Subject: Supplementary Information to DCP_NRC_002744 – Re-submittal of Proposed Changes for AP1000 Design Control Document Rev. 18

Supplementary - Proposed Changes for AP1000 DCD Rev. 18
(Non-Proprietary)

Clear DCD Page Mark Ups for Change Numbers 6, 7, 9, 25, 41, and 45

Figure 3: Proposed Changes to DCD Figure 9.2.2-2 (Sheet 1 of 5)

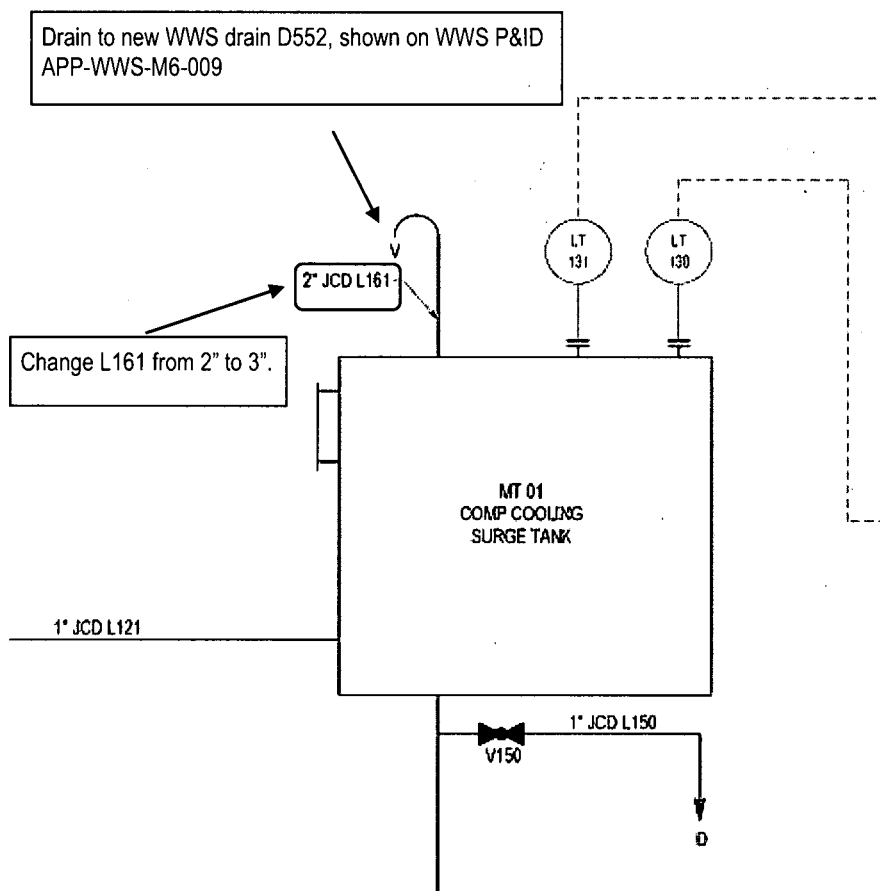
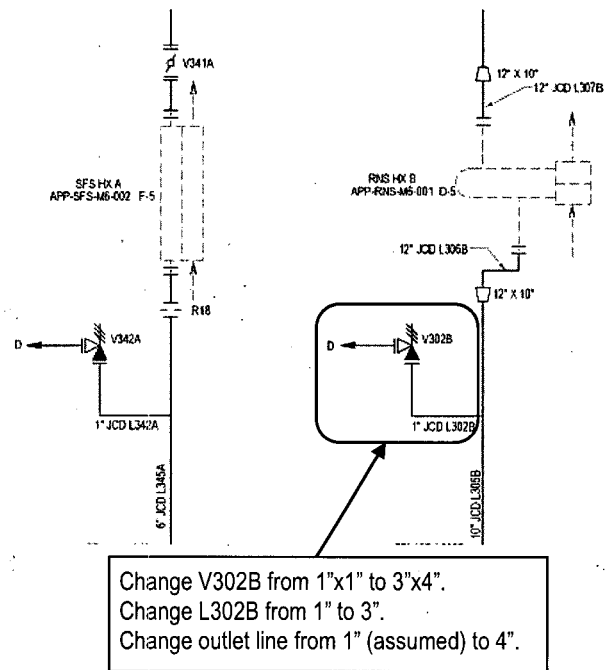
| 5. (#6 and #9) CCW surge tank, relief valves – figure not legible | (See Enclosure 3/5) |

Change Number 6

Figure 9.2.2-2 (Sheet 3 of 5)

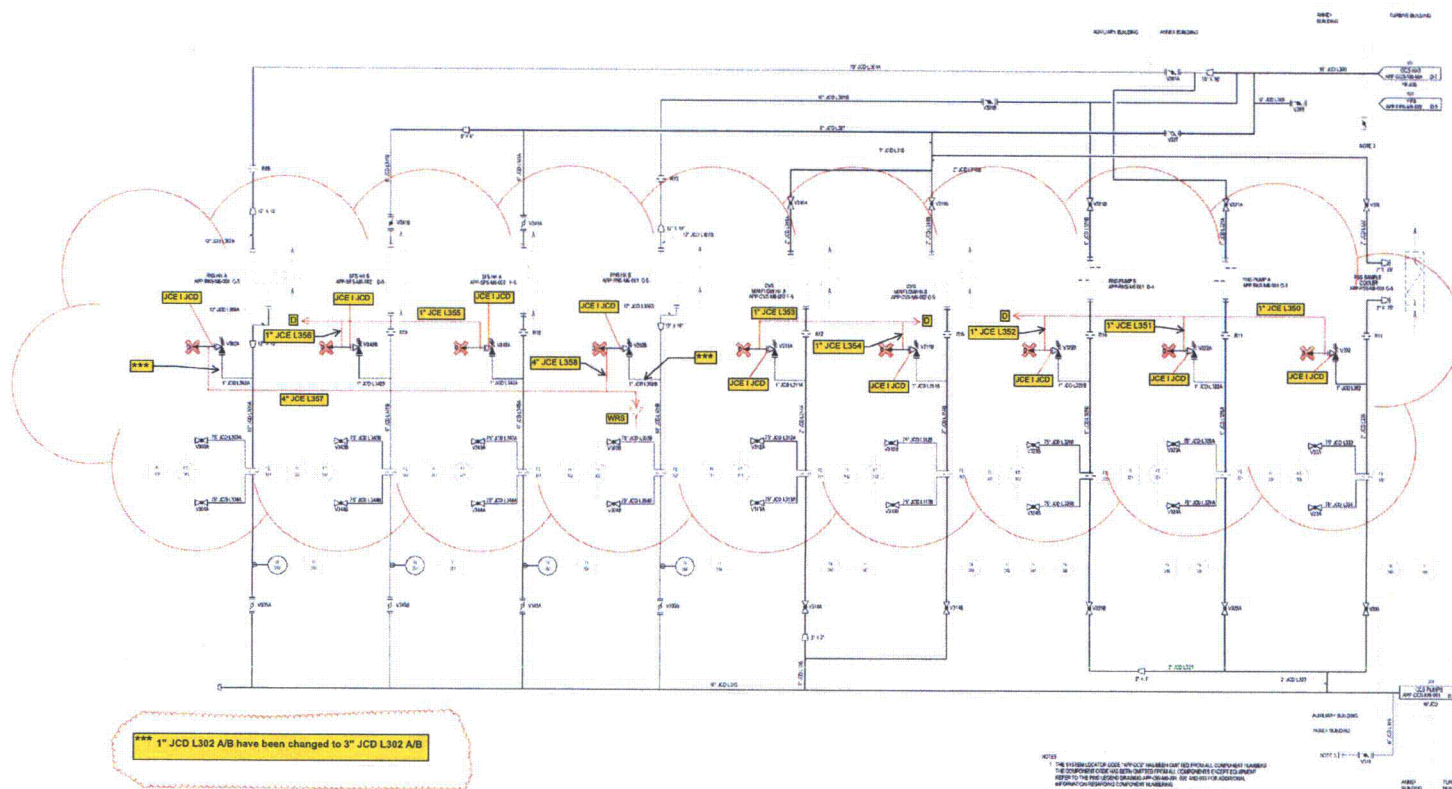
Change Number 9

Figure represents system functional arrangement. Details internal to the system may differ as a result of implementation factors such as vendor-specific component requirements.

19D.8.2.13 Float Level Sensors

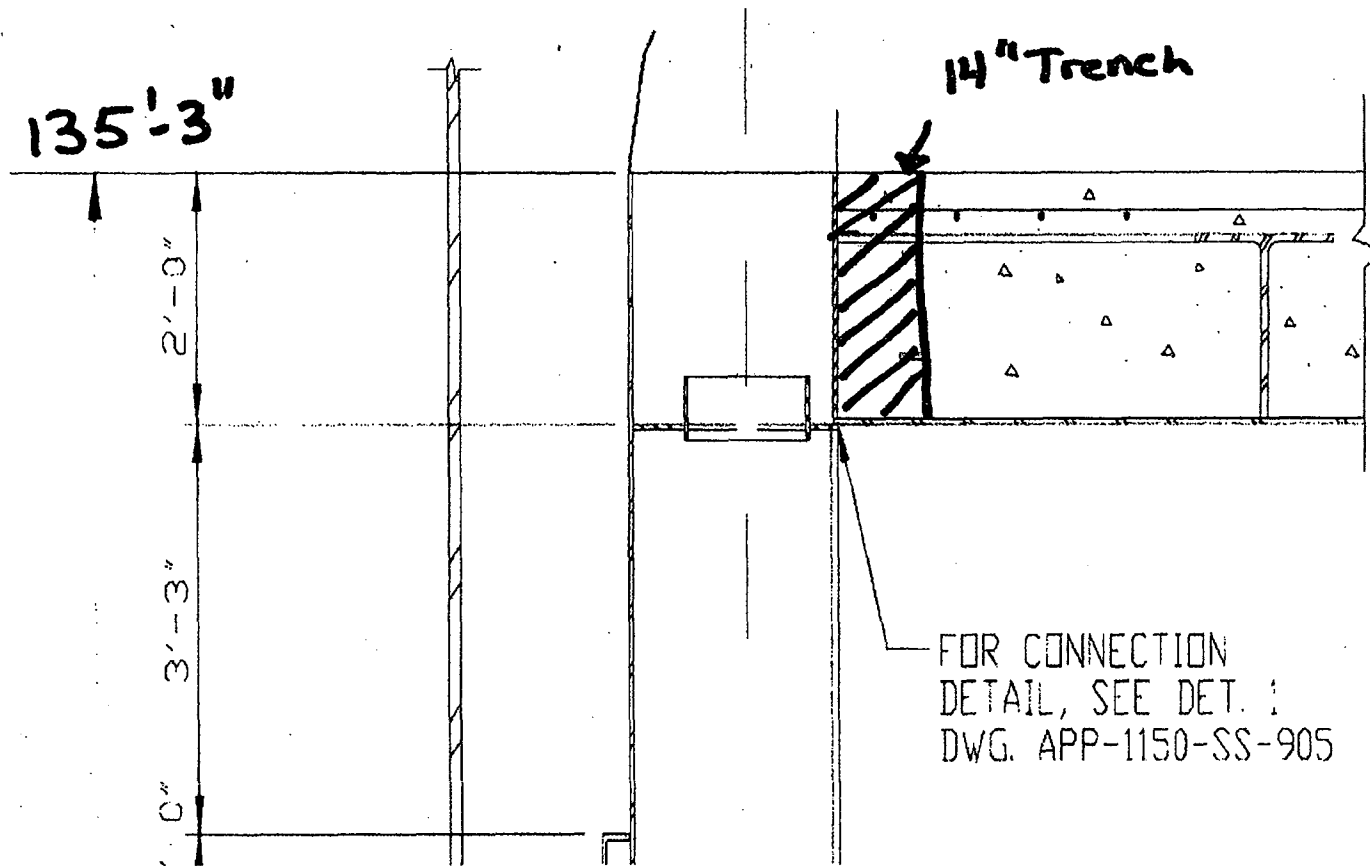
The function defined for severe accident management that utilizes float level sensors is containment water level. Containment water level is required through Time Frame 2. the temperature to which the float level sensors are exposed during the time frame does not exceed the float level sensor design.

19D.8.2.143 Assessment of Equipment for Sustained Burning

Figure 5.2-1

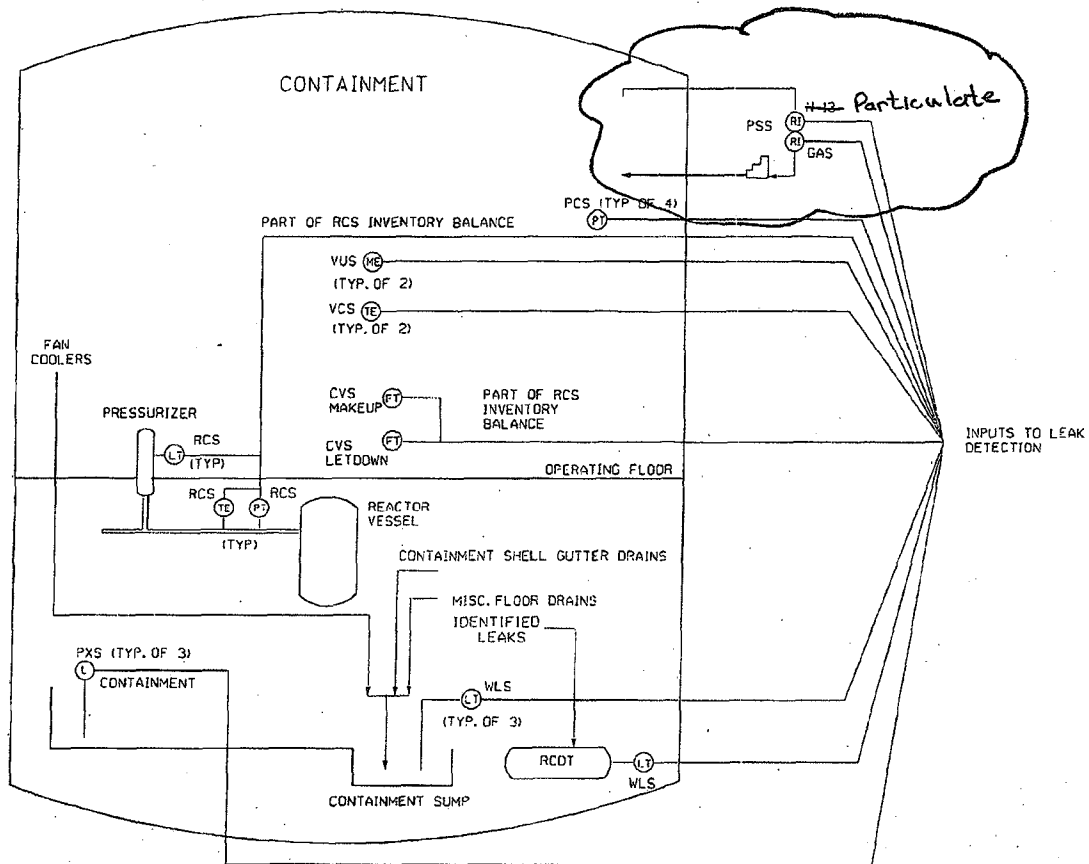
Change Number 45

Leak Detection Approach
